Agenda
Village of Arlington Heights
Zoning Board of Appeals
Buechner Room, 1st Floor

Arlington Heights Village Hall
33 S. Arlington Heights Road
Arlington Heights, IL 60005
June 10, 2019
7:00 PM

**Zoning Board of Appeals
6/10/2019**

EXISTING
PLANS ELEV
A1

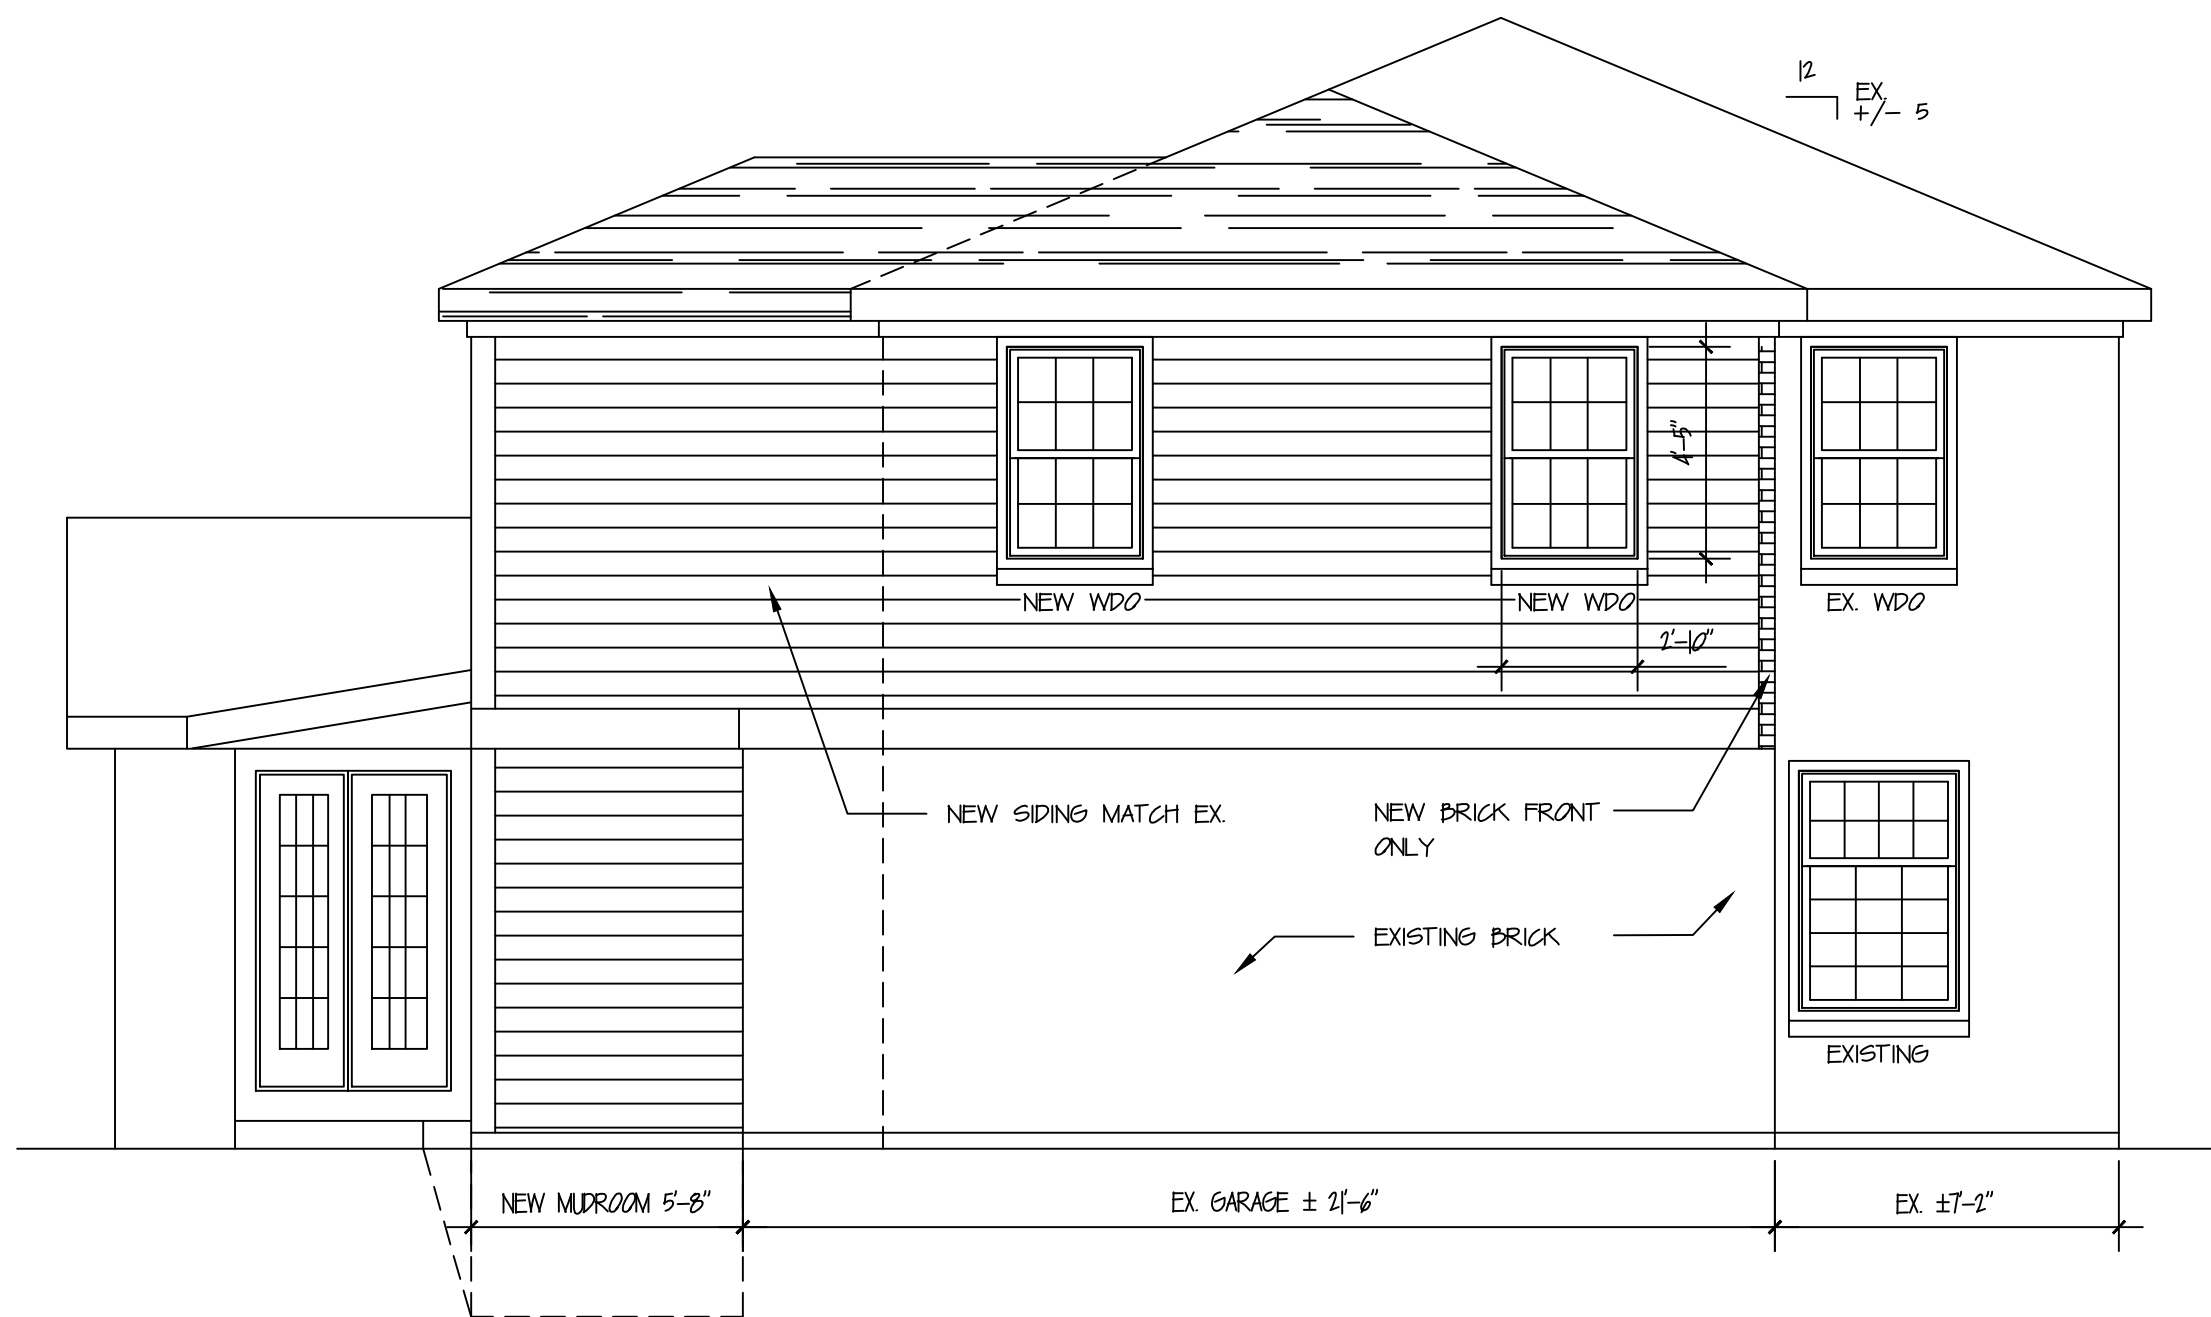
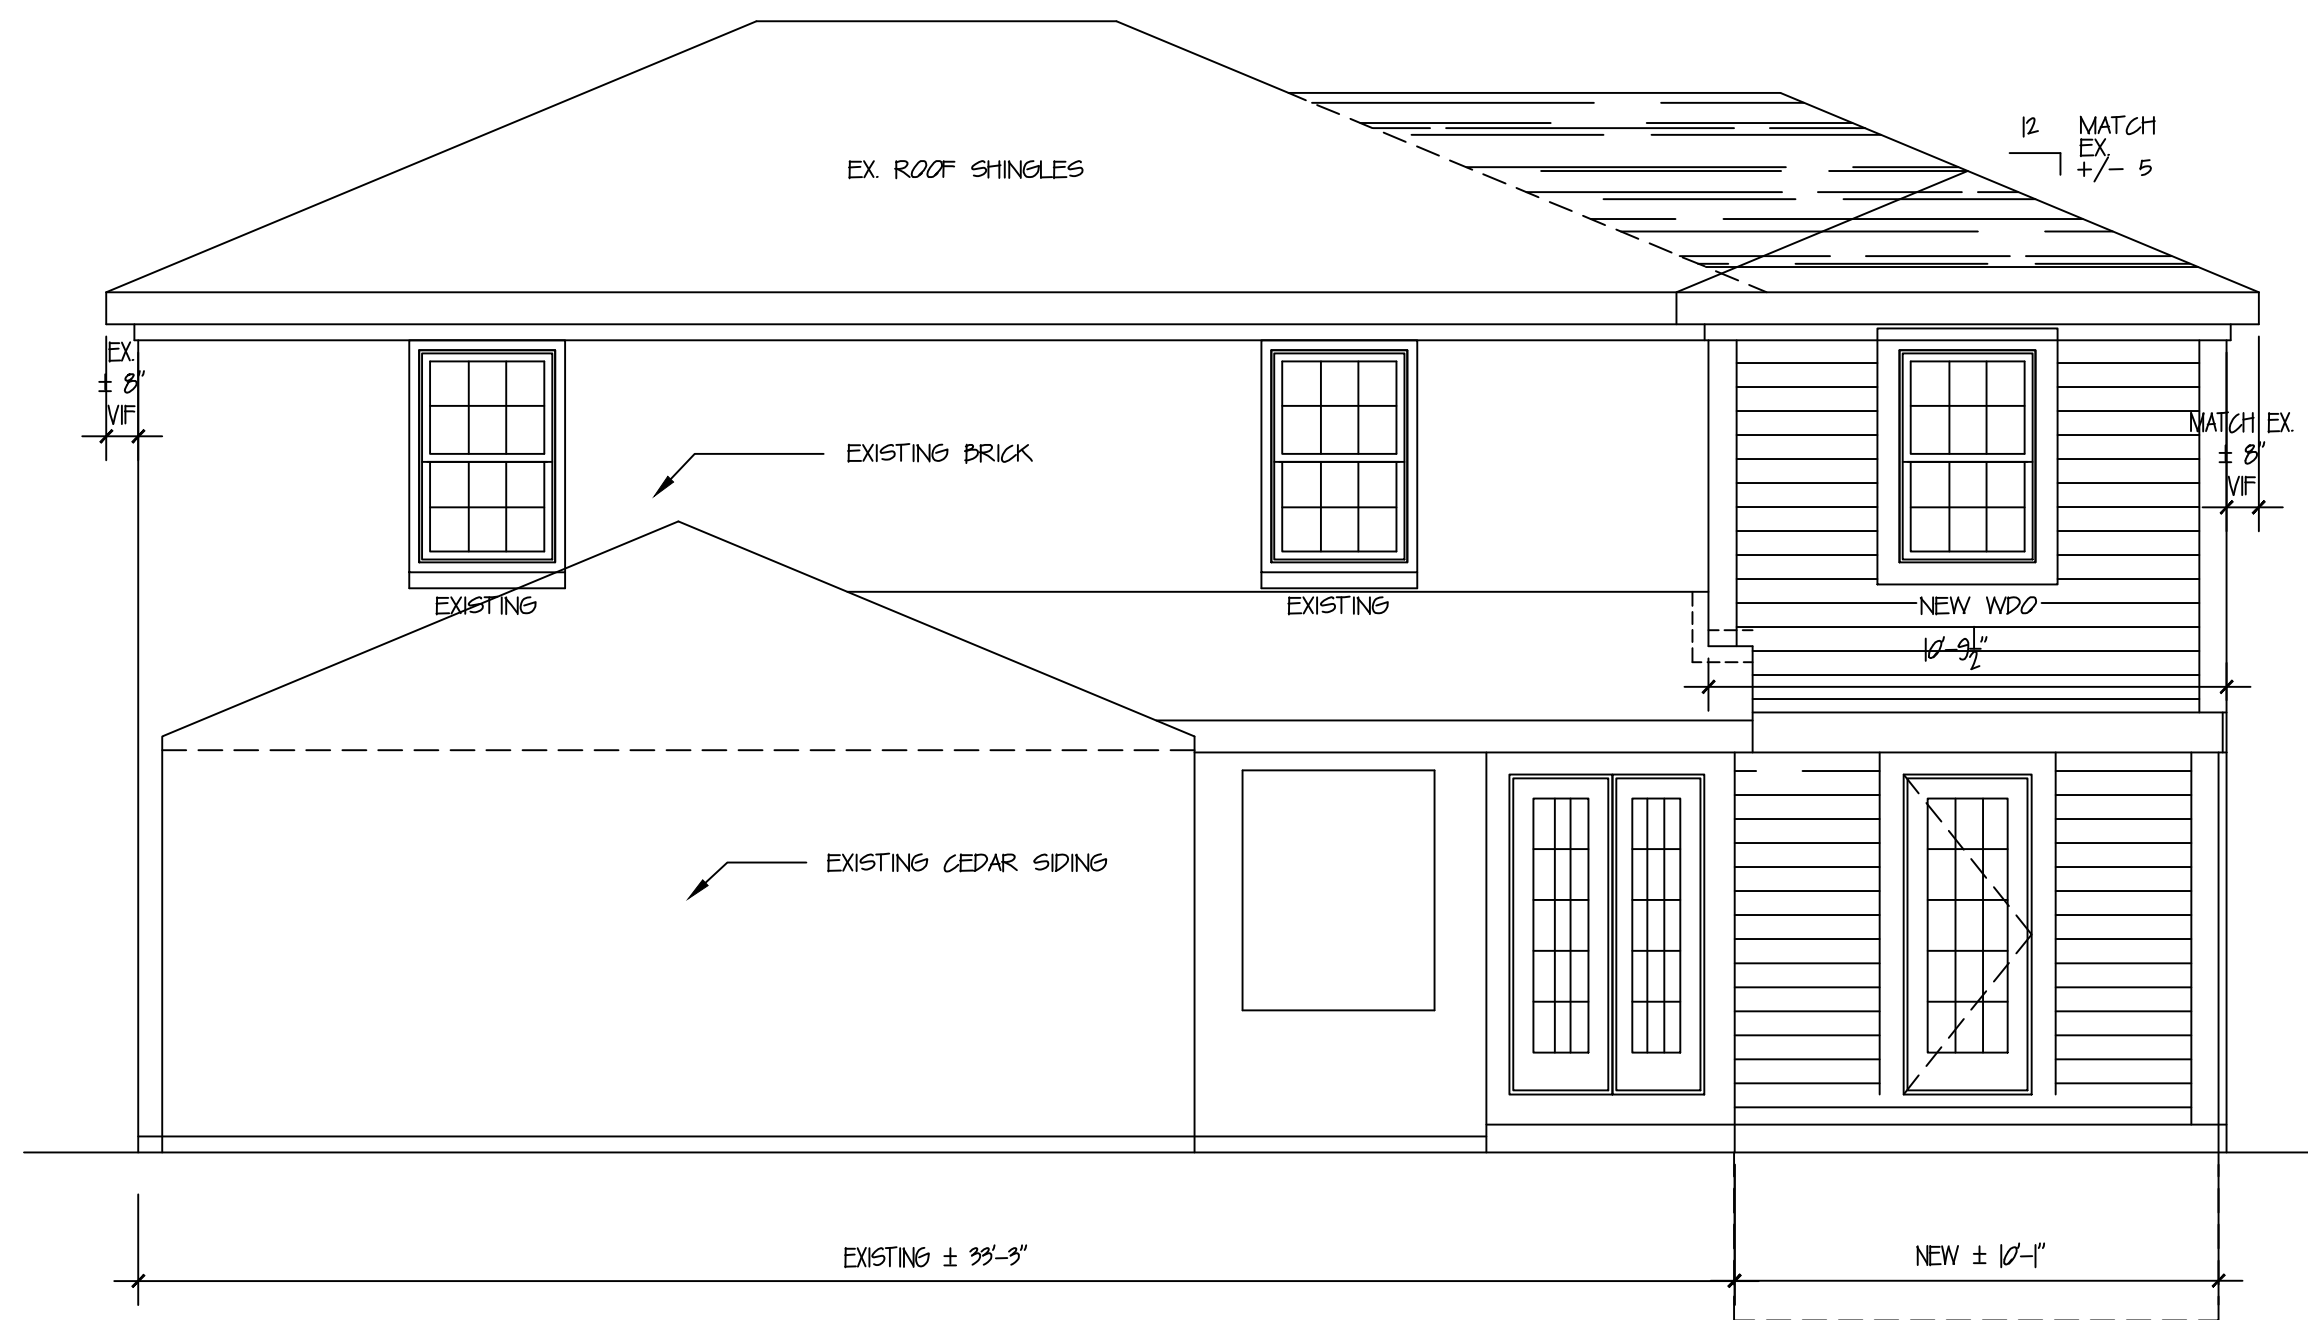
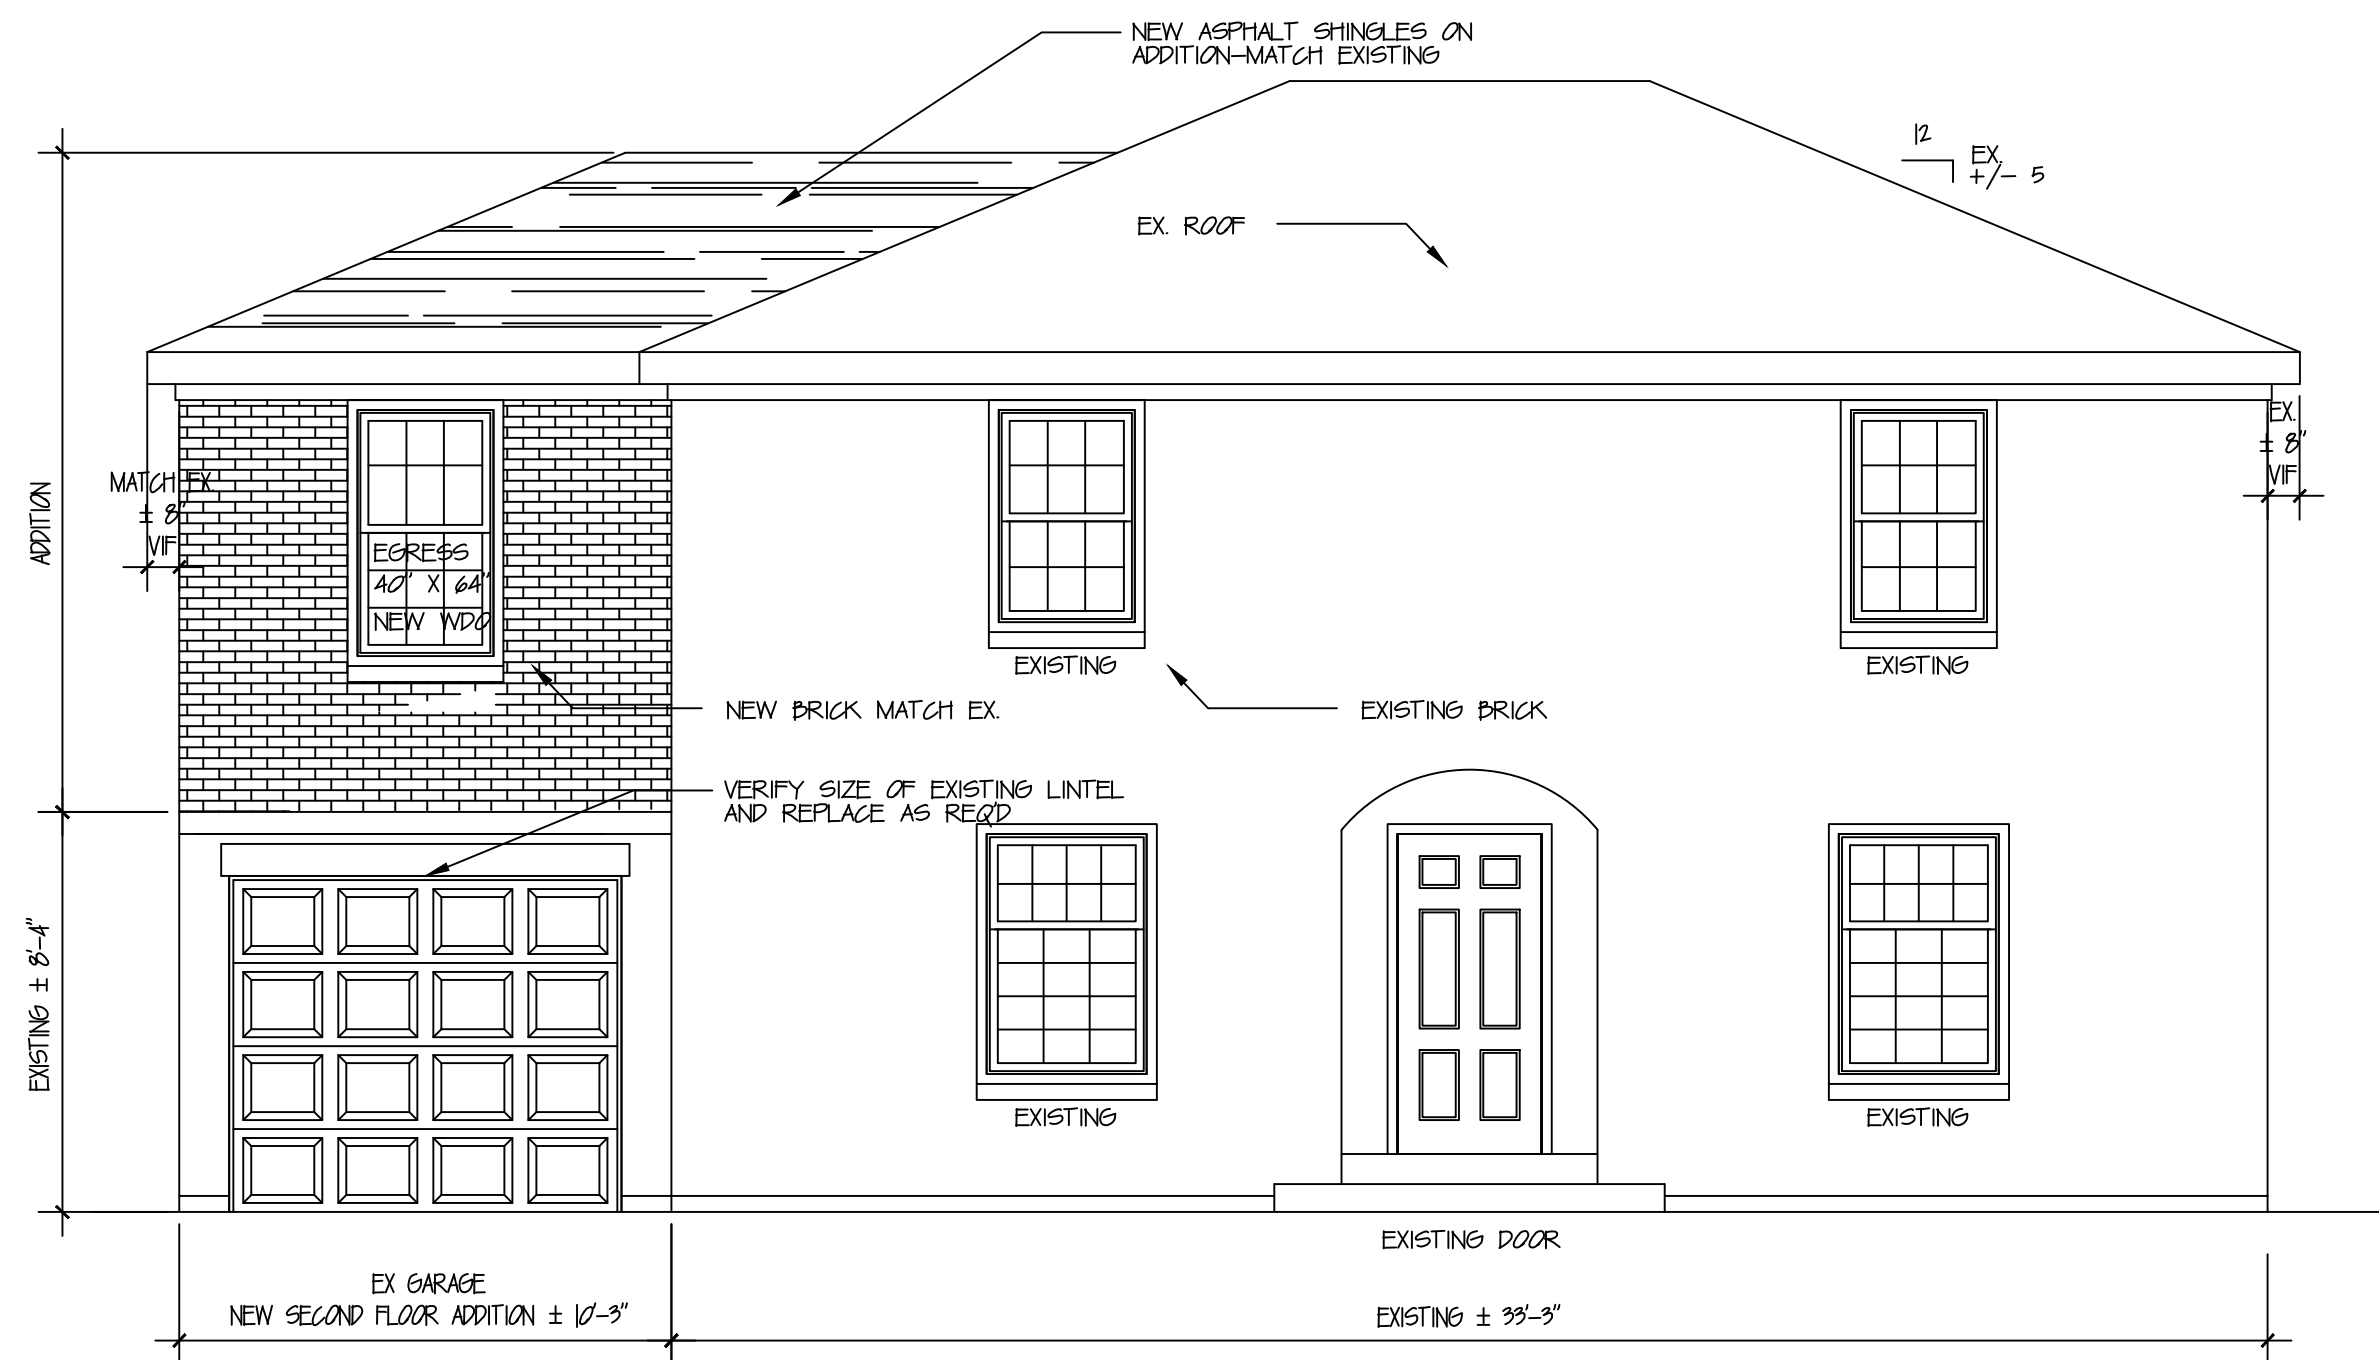
Comments: A DESIGN COMMISSION APPLICATION IS REQUIRED FOR REVIEW,
BUT THE PROPOSED ADDITION IS VERY NICELY DESIGNED TO FIT
W/ THE EXISTING HOUSE. - STEVE HAUTZINGER, DESIGN PLANNER
